The Corporation of the City of Kawartha Lakes
Committee of Adjustment Report – Canadian Tire Corporation Ltd.
Report Number COA2019-054

Subject: The purpose and effect is to request relief from the following zone provisions in order to permit an expansion to the existing retail store:

The variances are requested at 563 County Road 121, geographic Township of Fenelon (File D20-2019-034).

**CTC FENELON FALLS
STORE No.0038
Parking Illustration
Ford F150**

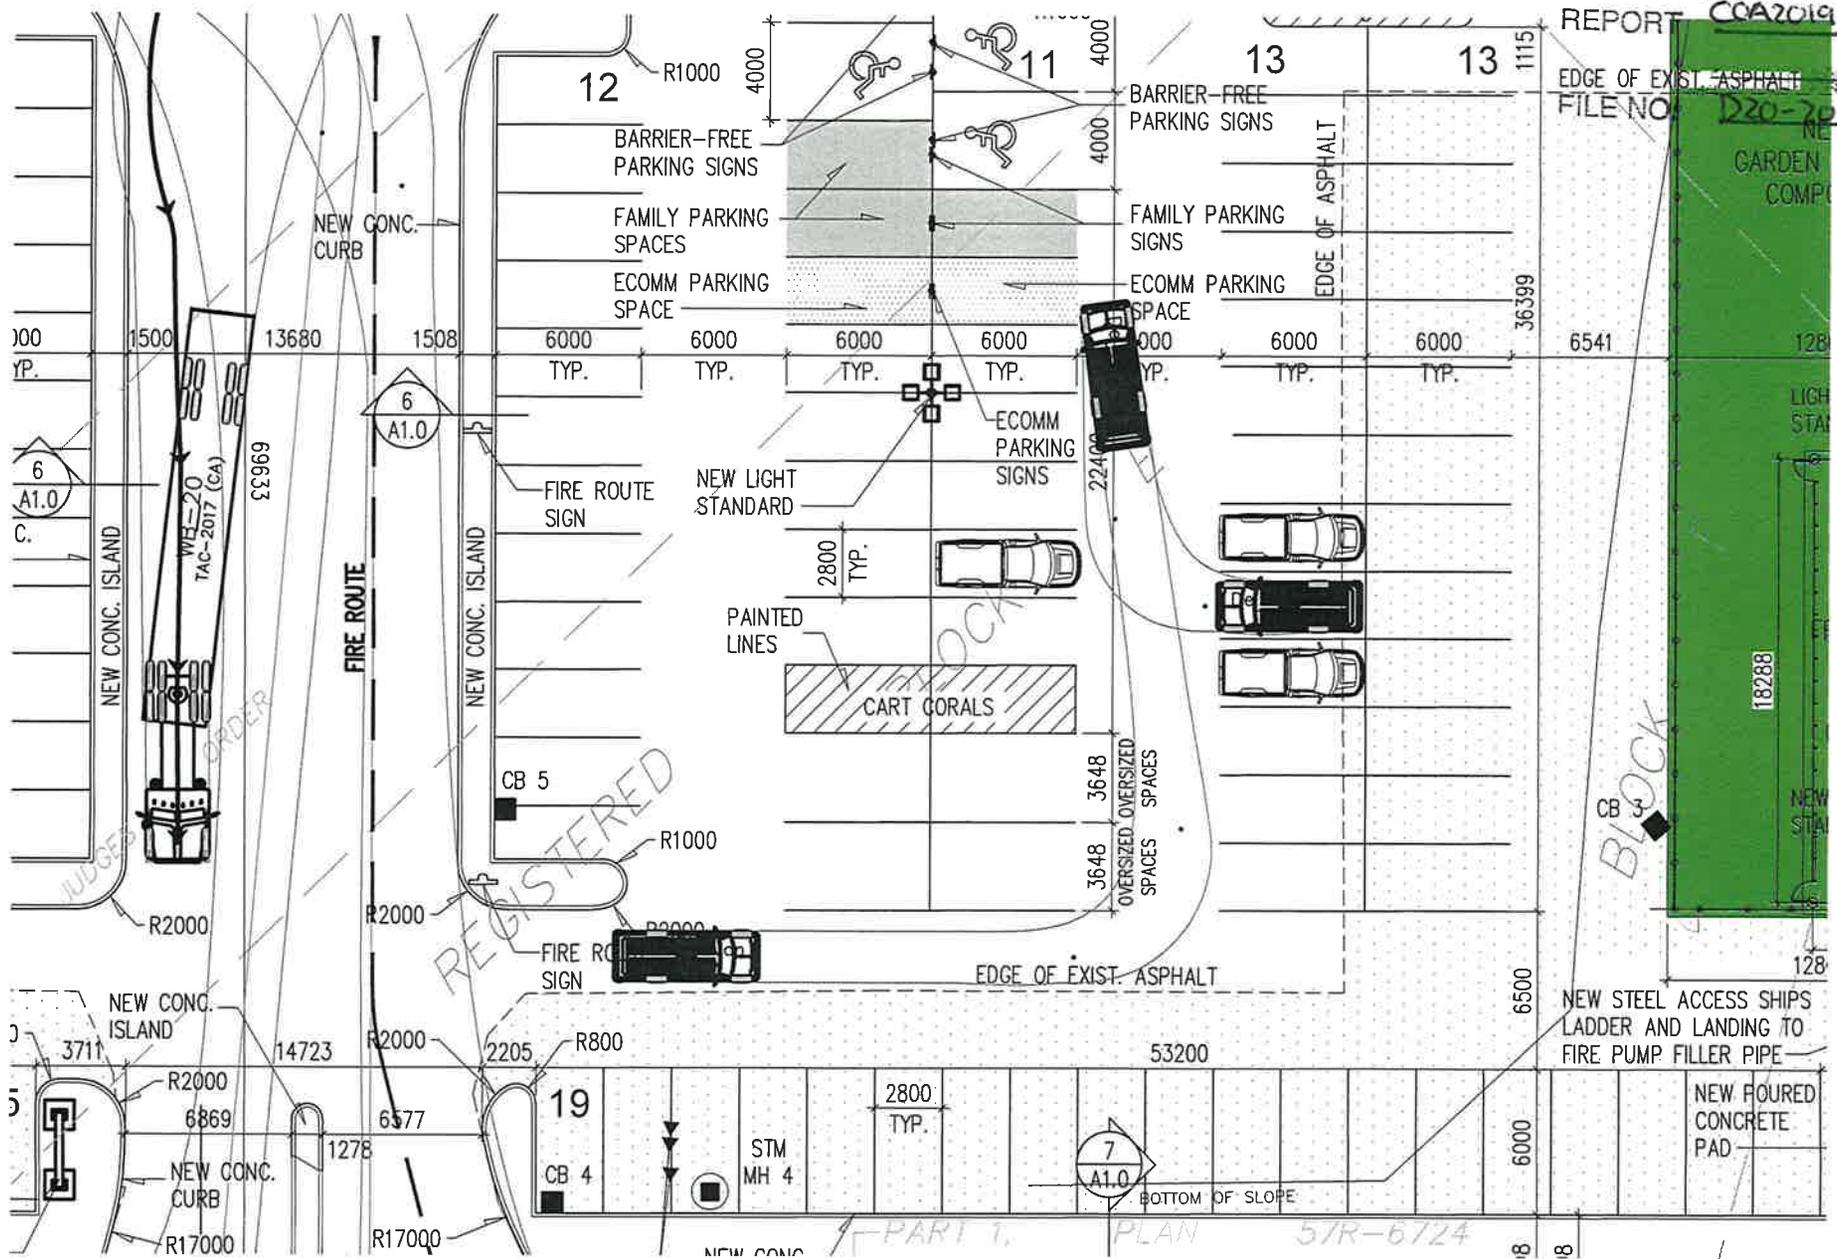
During a site inspection on July 31, 2019, it was noted that a large number of vehicles visiting the retail store were trucks and larger vehicles. Based on some preliminary research on vehicle dimensions, it was determined that a typical standard cab truck with a long bed (box) is approximately 18.5 feet (5.64 metres) in length. A double cab truck with a regular bed is slightly more than 19 feet (5.87 metres) in length, while a larger crew cab truck with a standard bed can be up to 20 feet (6.1 metres) in length. A concept plan showing how the reduced aisle width will function has been provided (See Appendix 'E').

Staff note that this proposed concept plan has not utilized double or crew cab trucks with a standard bed. Staff have determined that the same number of parking spaces can be accommodated utilizing a 7.0 metre aisle width (See Appendix 'F'). Given the concept plan does **not** demonstrate that the reduced drive aisles will accommodate the largest size trucks, the variance is not desirable or appropriate for the land.
